PLATEAU MINING COMPANY

July 27, 1984

RE: Plateau Mining Company, Sediment Control Plan Decant Pipe Modification for Ponds #4, #5 and #6

RISER PIPE RATING CURVES

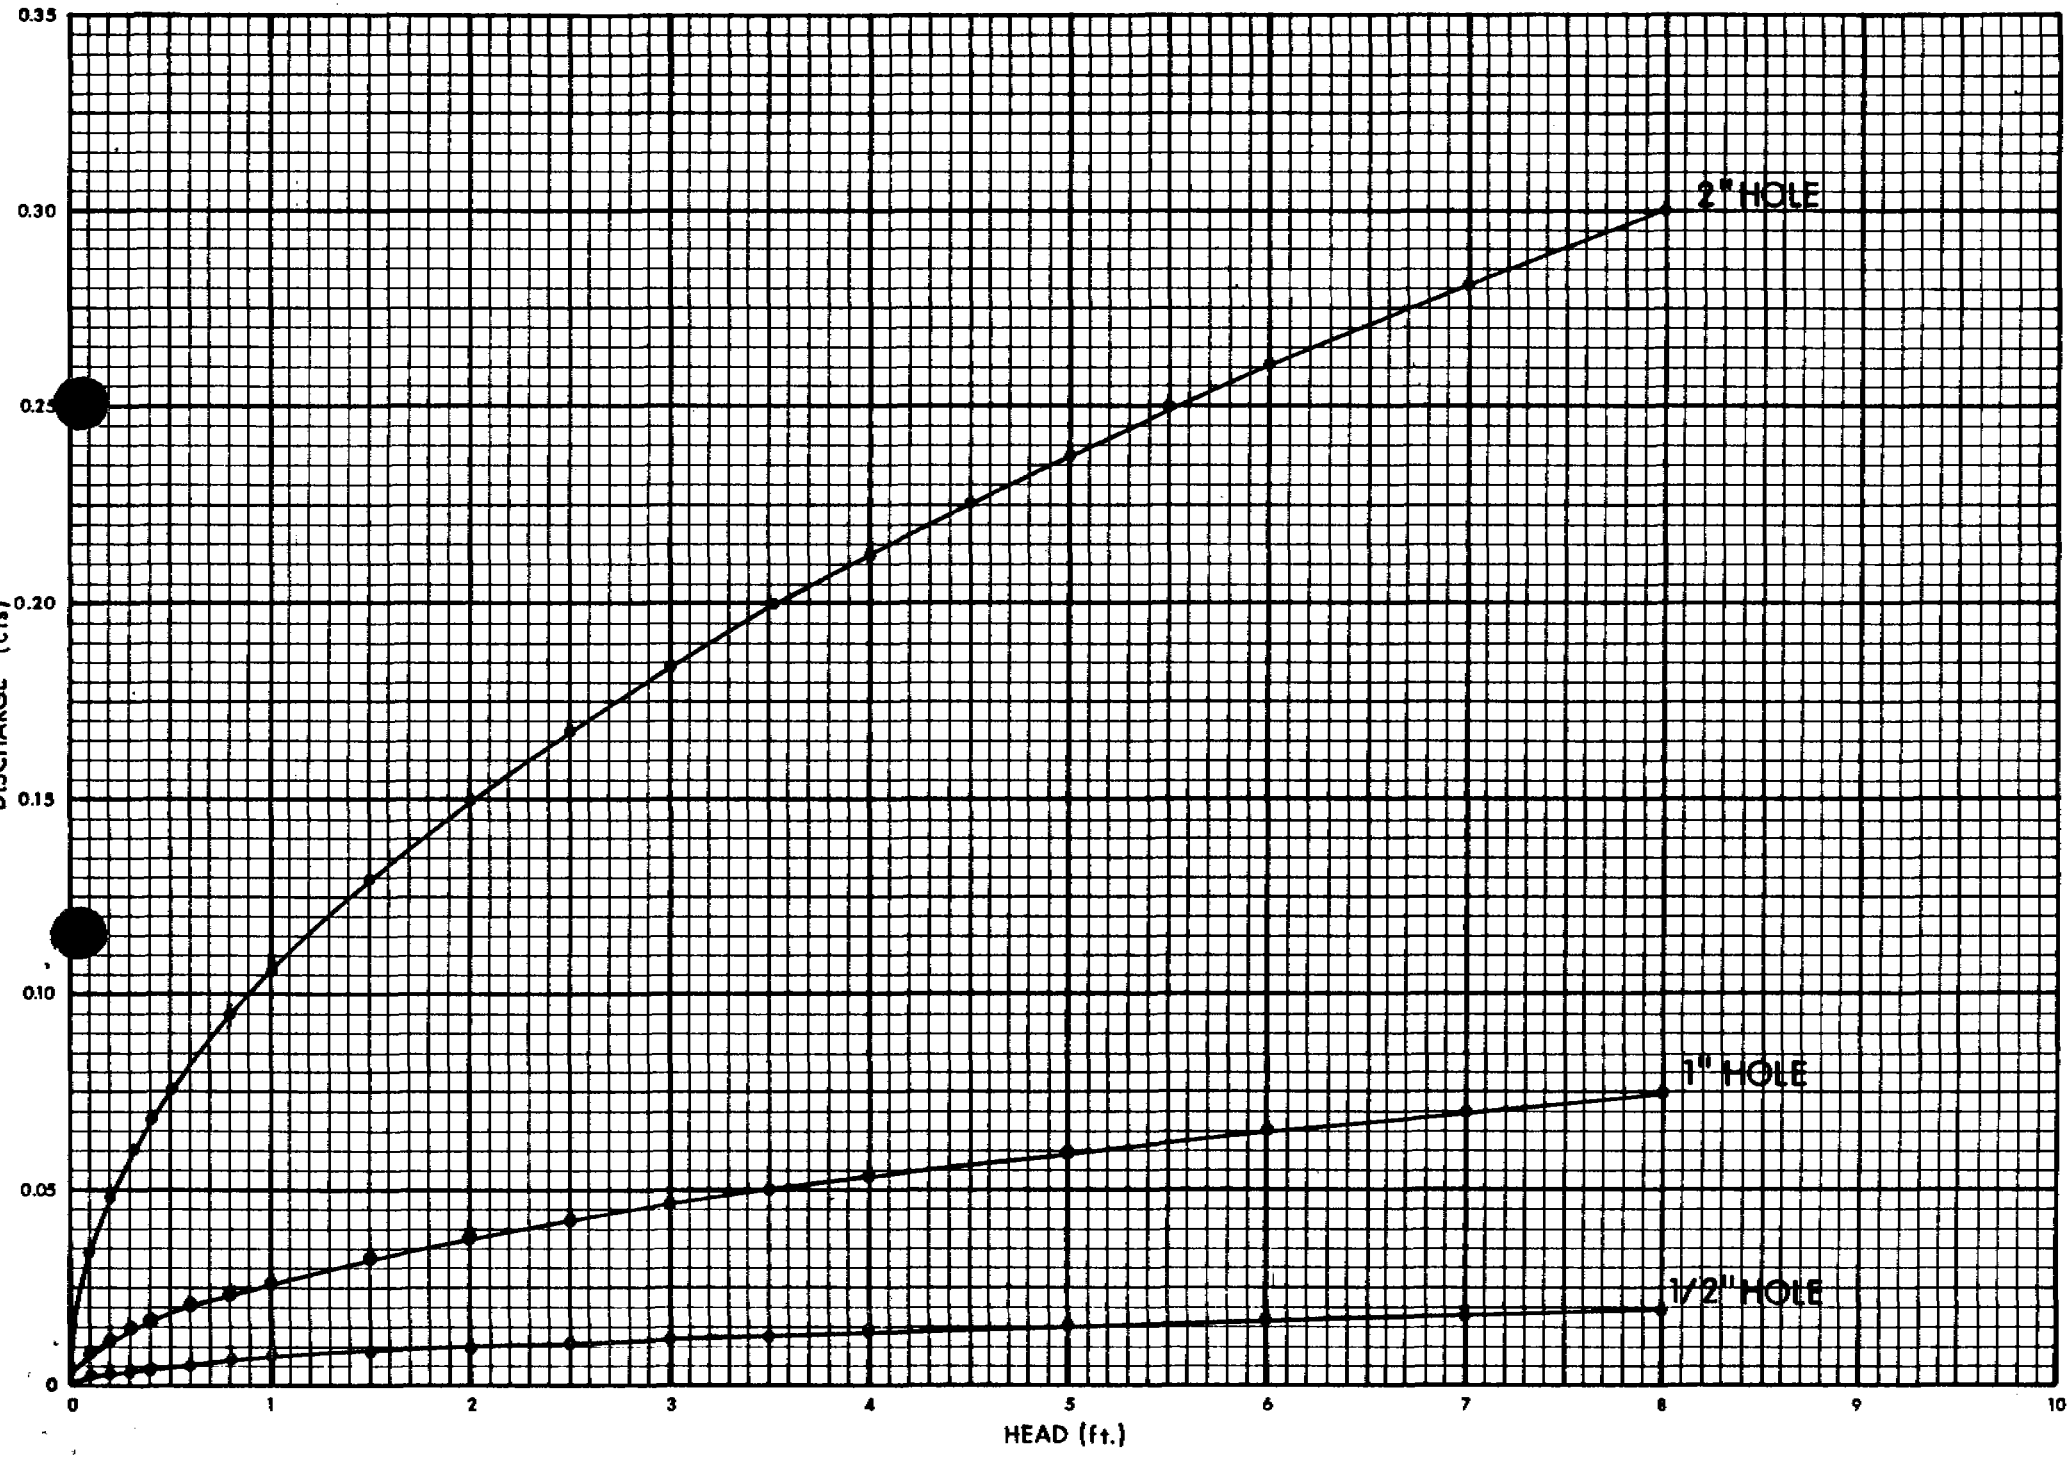
2. An updated and corrected orifce rating table.

The values of head vs. discharge for the 1" orifice have been recalculated and tabulated on the attached Orifice Rating Table, and Riser Pipe Rating Curves.

SEDIMENT SIZE DISTRIBUTION - POND NO. 4

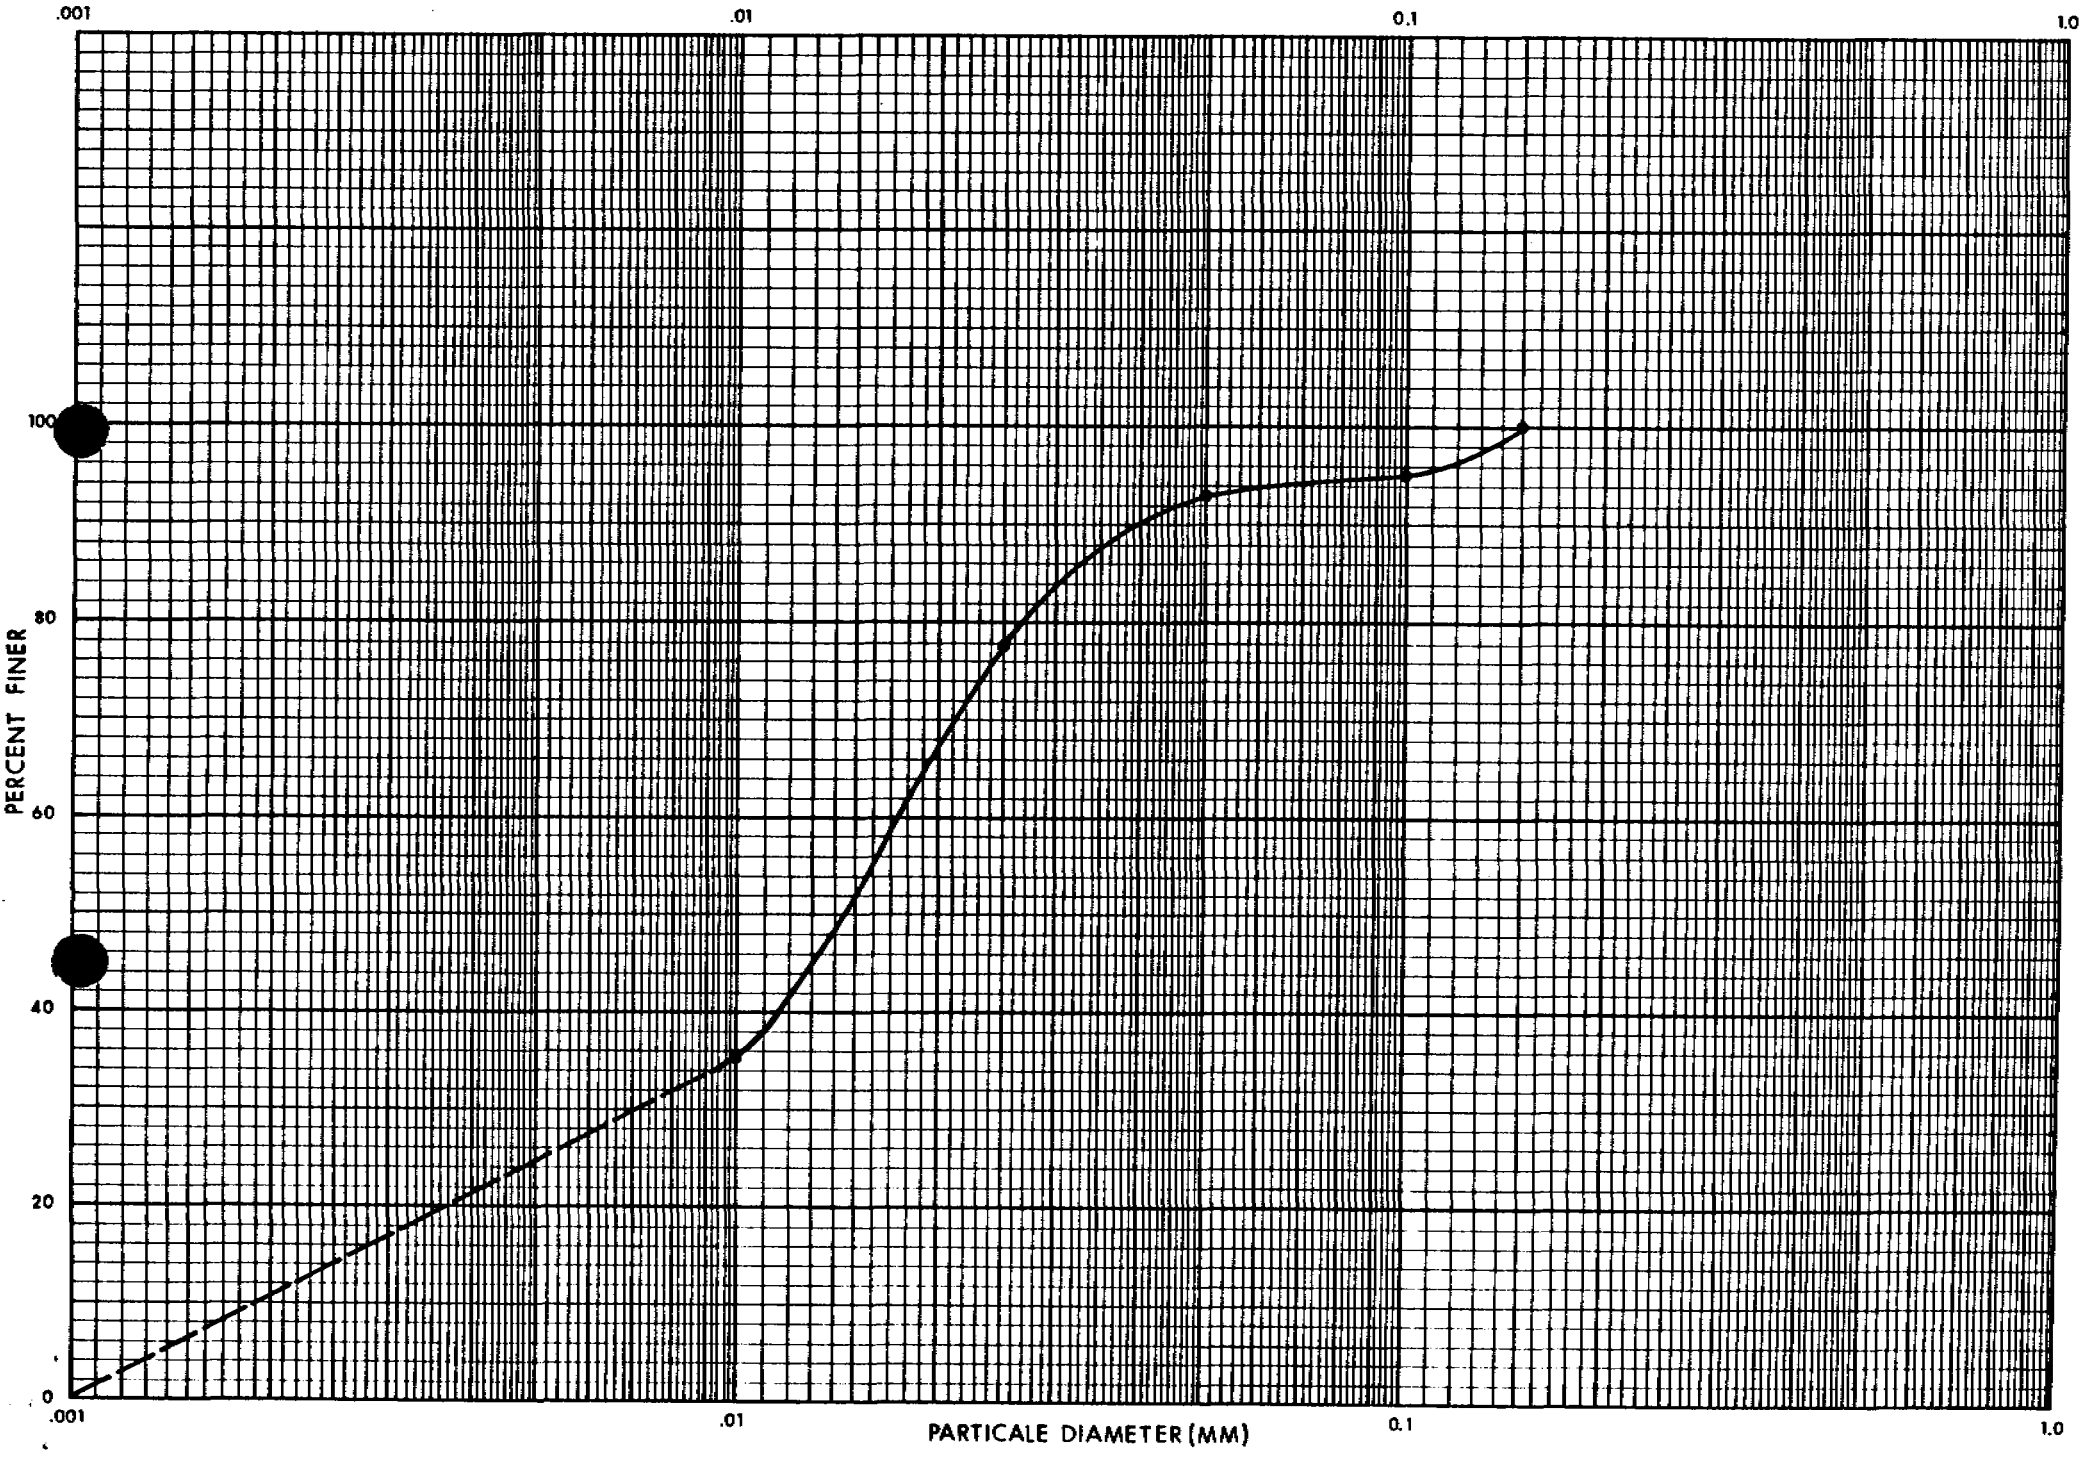
4. Results of partical size analyses for undispersed samples.

RESPONSE:
To our understanding, the sediment samples collected and analysed were undispersed samples. The method of sampling was to dredge a bedload sample from each pond, rather than to collect representative soil samples from the watershed. The samples were collected directly from and are representative of sediment actually entering each pond.
